Project  
**East West Rail (Western Section) Phase 2**

Drawing Title  
**PASSING PLACE A3\_P\_2 GENERAL ARRANGEMENT**

### Stage 2 Road safety audit response report

### Offline Highways Passing Places – Package 2 – Oxfordshire (A3 Marsh Gibbon – Compound Access)

Drawing Title  
**PASSING PLACE A3\_P\_2 EXISTING UTILITIES AND SITE CLEARANCE**

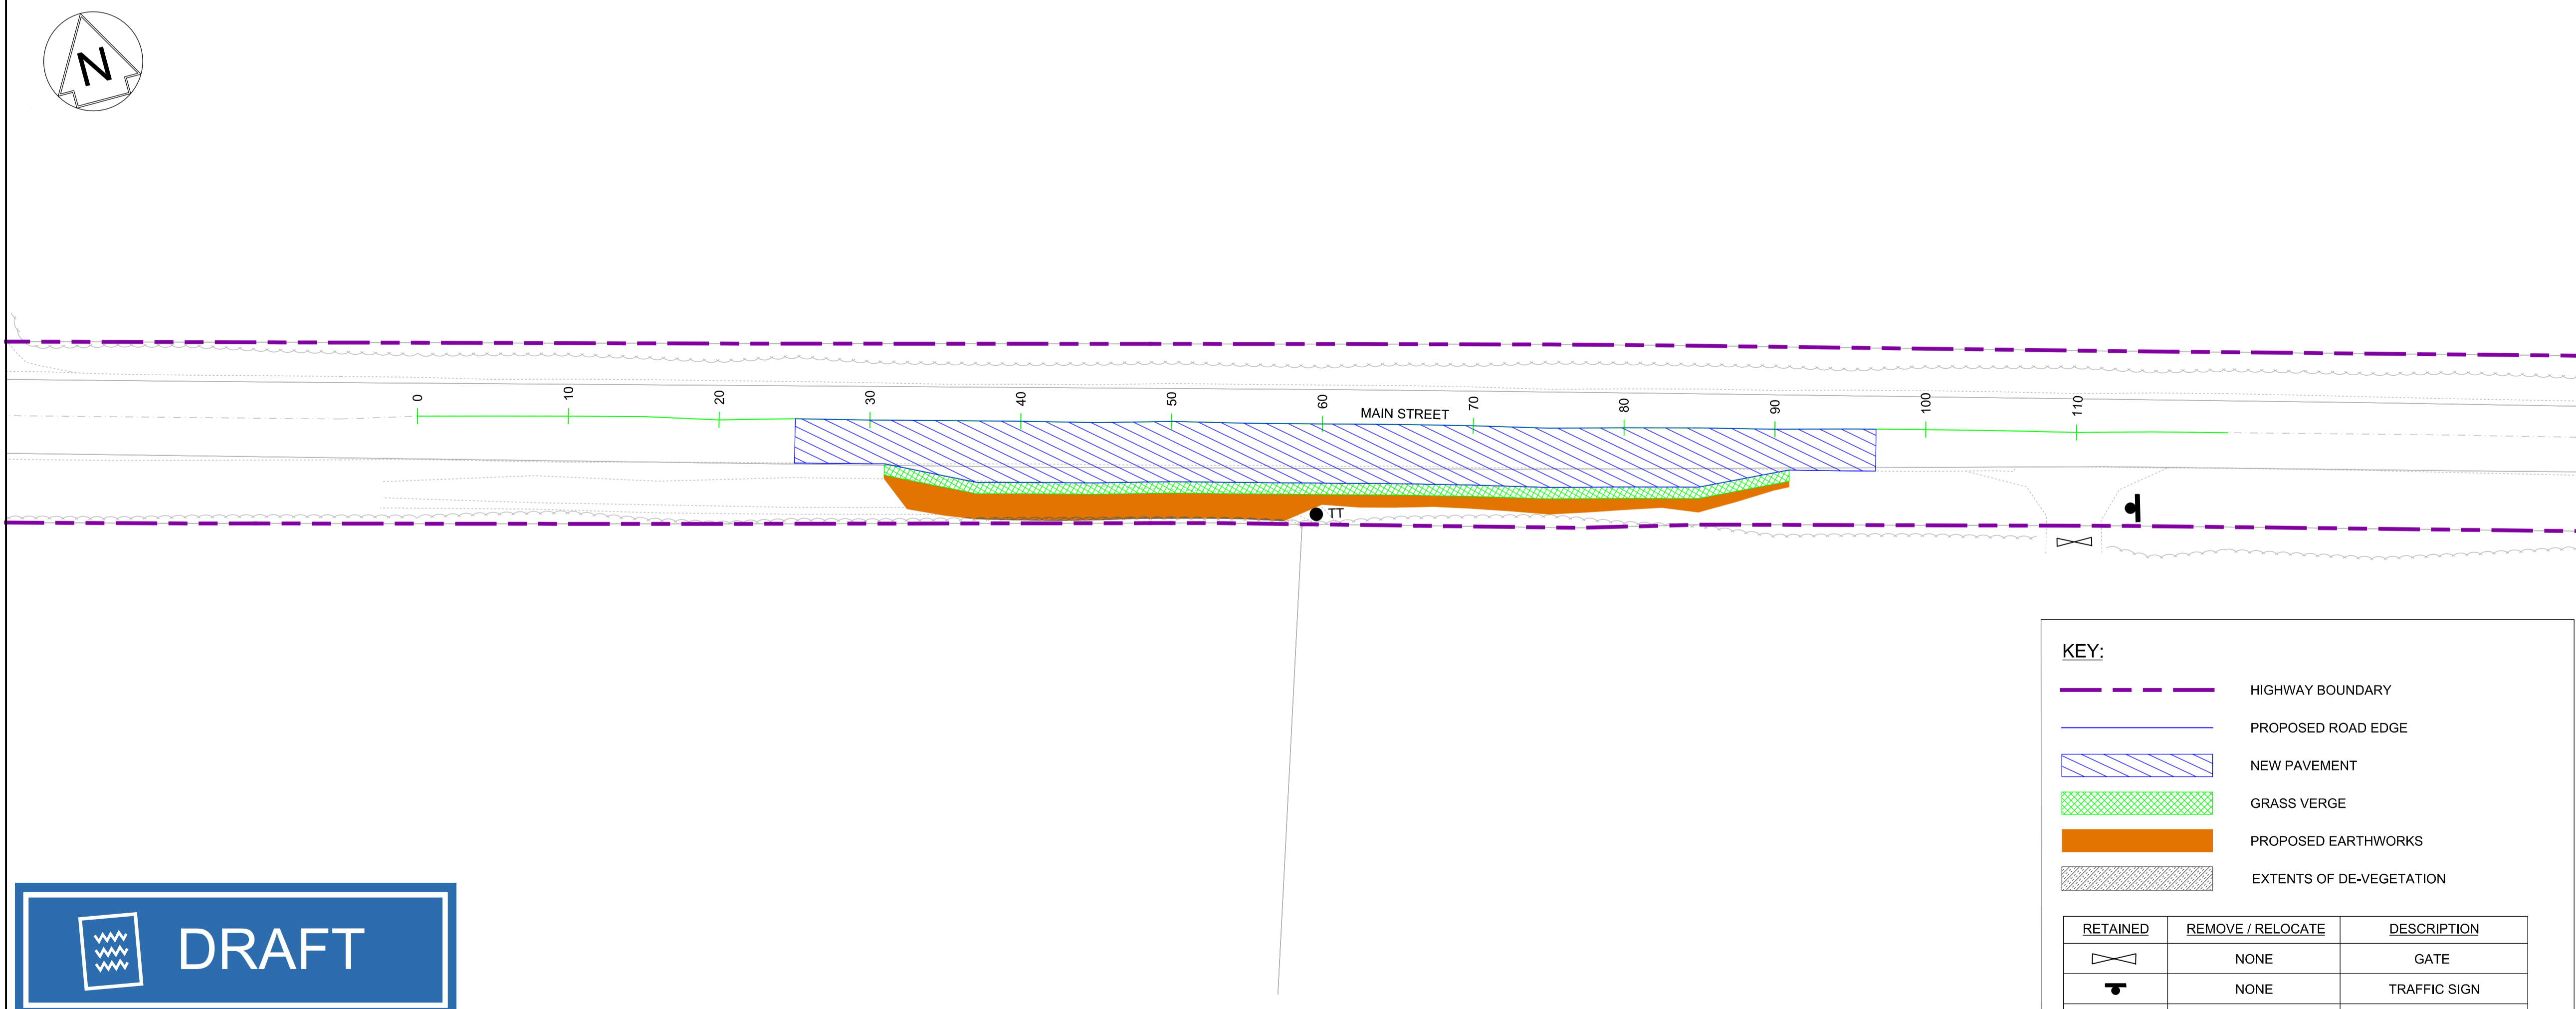
2.2	Passing Place A2-P-8. Unnamed Road (towards Mill Road).	<b>Disused signpost increases potential severity of collision</b> There is a disused signpost in the nearside verge heading westbound on Unnamed Road (towards Mill Road), opposite the proposed passing place A2-P-8, which presents an unnecessary hazard to a vehicle, should a collision occur at this location. The likelihood of a vehicle striking the disused signpost is increased by the location of the passing place opposite as vehicles may pass closer to the verge to avoid construction traffic. This disused signpost may therefore lead to an increase in the collision severity should one occur.	Remove disused signpost.	<b>Accept the RSA problem and recommendation made by the RSA team.</b> The disused signpost is included for removal in the Site Clearance Drawing.	Accepted	Proceed as Design Team Response

Drawing Title  
**SIGNAGE STRATEGY DRAWING FOR OXFORDSHIRE COUNTY COUNCIL**

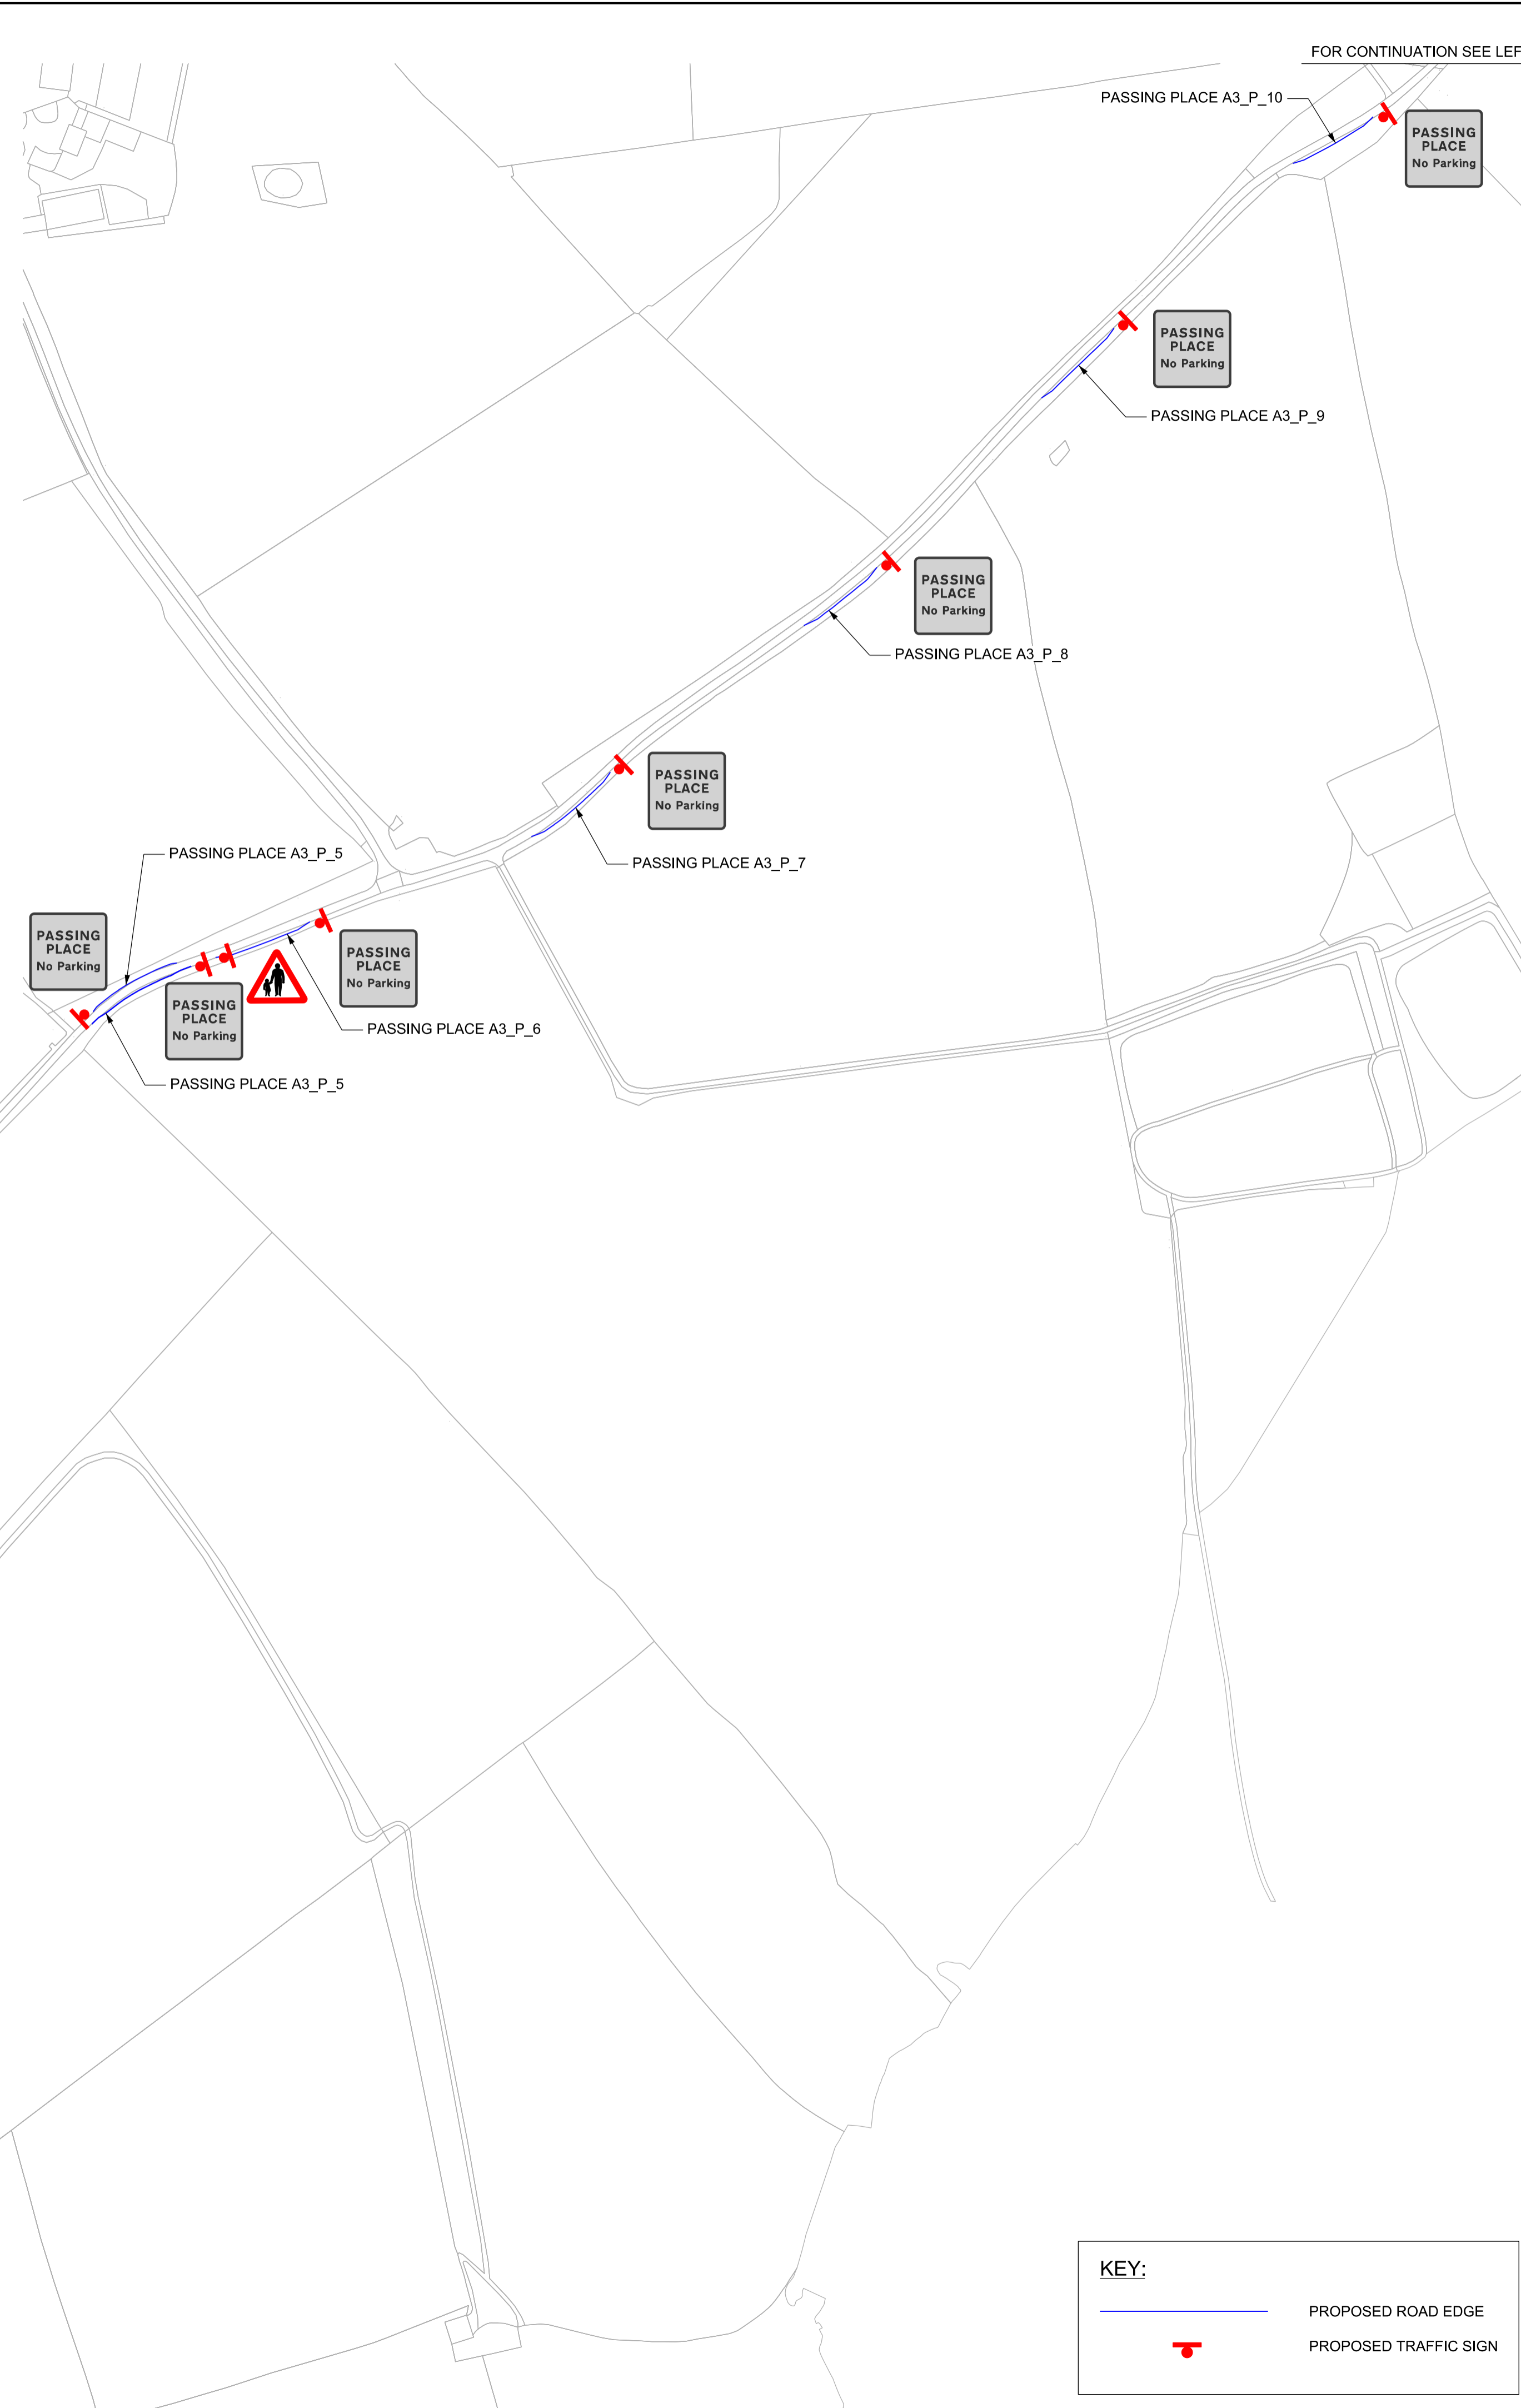
RSA Ref	Location	RSA Problem	RSA Recommendation	Design Team Response	Network Rail Response	Agreed RSA action
2.4	<p>Passing Places A2-P-1, A3-P-2, A3-P-3, A3-P-5, A3-P-7 and A3-P-10. Unnamed Road (towards Mill Road) and Unnamed Road.</p>	<p><b>Proximity of passing place to farm traffic access increases risk of collision</b>                      There are accesses used by farm traffic along the Unnamed Road (towards Mill Road). As a farm vehicle enters or exits these accesses from Unnamed Road (towards Mill Road), there is a likelihood that a construction vehicle may collide with it as they may not anticipate the turning farm vehicle, particularly when they are preparing to enter the passing place. This issue is exacerbated by the presence of vegetation around these accesses which reduces the visibility between farm traffic and construction drivers using the Unnamed Road (towards Mill Road).</p>	<p>Provide traffic signing to warn of construction passing places and farm traffic accesses. Trim back vegetation around the accesses to maximise intervisibility</p>	<p><b>Accept the RSA problem and recommendation made by the RSA team.</b>                      The design includes a signage strategy which provides signs to notify drivers that the road has passing places. The site clearance drawings include vegetation clearance to achieve required visibility and signage strategy drawings likewise include this provision.</p>	Accepted	Proceed as Design Team Response
